PASCO COUNTY, FLORIDA  
INTEROFFICE MEMORANDUM

FROM: Carol B. Clarke  
Zoning Administrator  
Assistant Planning and Development  
Administrator    SUBJECT: Behnke/Legacy MPUD  
Master Roadway Plan and  
Alternative Standard  
DRC: 5/22/14, 1:30 p.m., NPR  
Recommendation: Approval

**BEHNKE RANCH  
MASTER ROADWAY PLAN  
PASCO COUNTY, FLORIDA**

## Behnke Master Roadway Plan Comments #1 - Applicant Responses

**RS70B**  
POSTED SPEED / DESIGN SPEED 20 MPH  
2

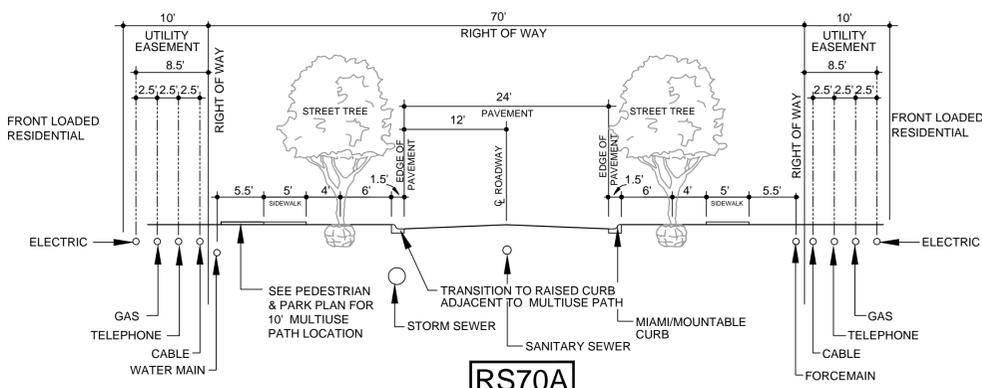
8. Street classifications on the plan view do not match the street classifications in cross-sections. For example, RS 70B is labeled as "2" in plan view and "4" in cross-sections.

***Response: Acknowledged, plans have been corrected.***

**ST70**  
POSTED SPEED / DESIGN SPEED 25 MPH  
A

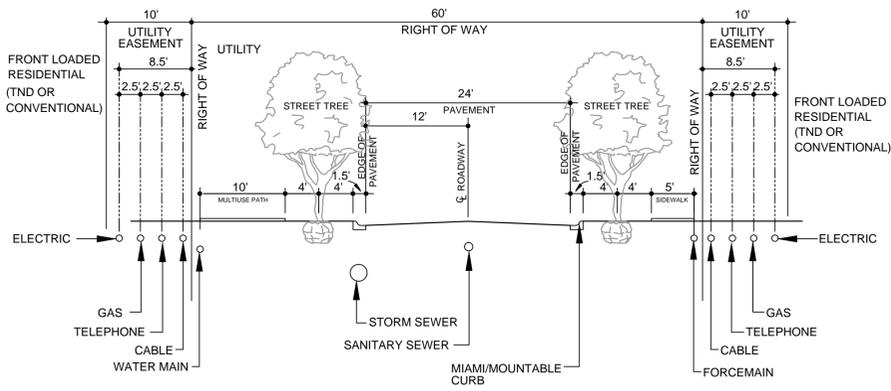
1. For Portion of the ST70, increase ROW to 80' on each side of AV100 to accommodate on-street parking on the south side of ST70 for the portion of ST70 abutting the proposed mixed use areas.

***Response: The plans have been revised so that on street parking is now planned for two areas on the south side of this roadway, both east and west of the T intersection. As discussed and agreed with Pasco County Staff the parking improvements as shown should be viewed as a commitment to construct at the time of development for the commercial parcels. Because the development configuration of the commercial parcels is unknown at this time, the installation of these improvements have been committed to the future.***

**RS70B** ROADWAY CROSS SECTION

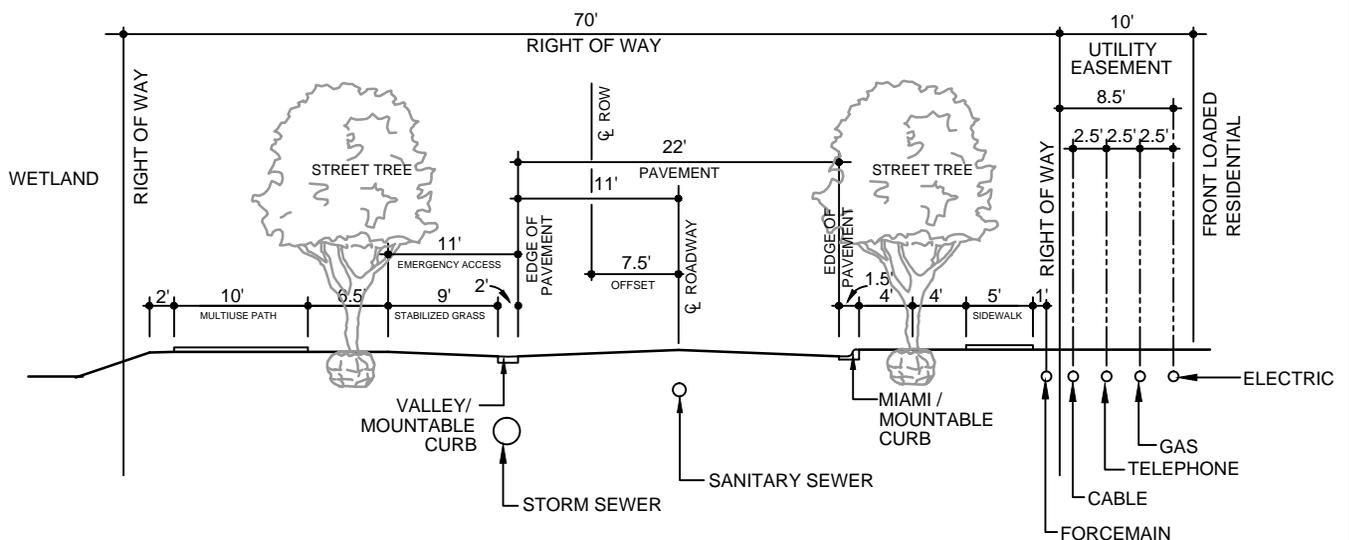
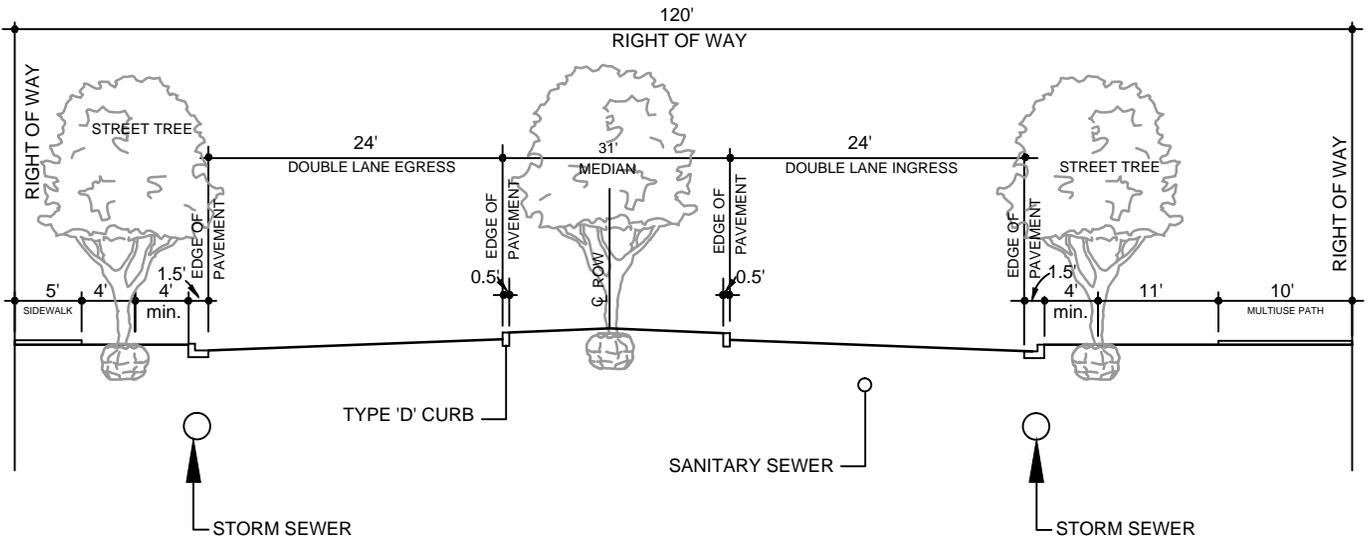
- a. The proposed 11-foot-wide stabilized grass Emergency Access section is designed to allow the travel of emergency vehicles over it, and adheres to the LDC, Chapter 900, Section 901.3.H, by providing one single emergency lane. The addition is a third 11-foot-wide lane as the emergency access, with a two-foot-wide curb is part of the emergency access and a nine-foot-wide stabilized grass strip. The proposed 11-foot-wide lane is located adjacent to the southbound lane and will serve the purpose of an emergency access. The roadway is located in the section of the road designated as RS70B on the Master Roadway Plan (MRP) that crosses a wetland.

The proposed emergency access lane will provide for an additional ingress/egress into a section of the property exceeding 100 lots which has no other access. A third paved lane would encourage drivers to drive faster. Using the stabilized grass area as an emergency lane instead of a paved lane will provide a wider green area buffer between the travel lane and the multiuse path, increasing the safety for the multiuse path users. The stabilized green area emergency lane will increase walkability due to narrower pavement.

4. The Alternative Standard from LDC, Section 901.3.H, Number and Spacing of Driveways, has been reviewed and approved by Planning and Development staff and by the County Engineer. The proposed 11-foot-wide stabilized grass Emergency Access section is designed to allow the travel of emergency vehicles over it, and adheres to the LDC, Section 901.3.H

2. Need approval from County Engineer to see if using 12' trail for emergency lane is acceptable. Provide Road Type 1A pavement cross-section and Structural Number details and trail-to roadway connection details to be reviewed by County Engineer. Alternative Standard from LDC 901.3.H is required.

***Response: Acknowledged. Our team met with the County Engineer and provided the detail requested. An Alternate Standard request has been provided with this submittal.***

AV114 ROADWAY CROSS SECTION

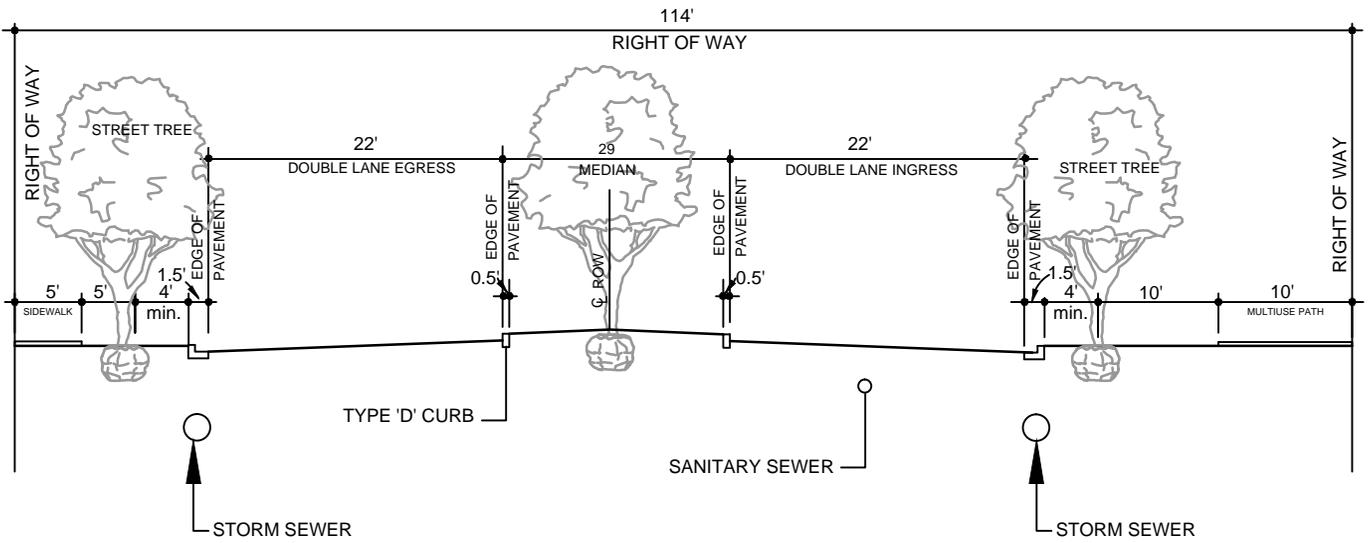
- a. The proposed request consists of reducing the lane widths from a 12-foot-wide travel lane to an 11-foot-wide travel lane, for a Type 1A roadway. The LDC, Chapter 900, Section 901.6.D.2. The request is for a road designated as AV114 shown on the Master Roadway Plan.

The proposed roadway has two northbound and two southbound lanes, each having a 22-foot pavement width, with left and right turn lanes. The 114-foot right-of-way also contains landscaping, sidewalk, and a multiuse path. This roadway serves as the entrance to a TND type development which has been designed to provide a walkable environment. The request for reducing the lane widths within this section is to extend a safe walking environment through the entrance. The Florida Department of Transportation (FDOT) Manual of Uniform Minimum Standards for Design, Construction and Maintenance for Street and Highways (Florida Greenbook), allows for 11-foot-lanes for collector streets in Chapter 3, Table 3-7.

5. The Alternative Standard from LDC, Section 901.6.D.2, Pavement Width, has been reviewed and approved by Planning and Development Staff and by the County Engineer. The proposed reduction of the lane widths from a 12-foot-wide travel lane to an 11-foot-wide travel lane, for a Type 1A roadway is consistent with the FDOT Florida Greenbook, which allows for 11-foot-lanes for collector streets. Staff agrees that the proposed alternative 11-foot-travel lane is more conducive to a walkable environment in a traditional neighborhood type of development.

3. Type 1 Roadway — AV100 shows 11' lanes. Reducing from 12' to 11' will be an Alternative Standard per LDC 901.6.D.2

***Response: Alternate Standard request has been provided.***
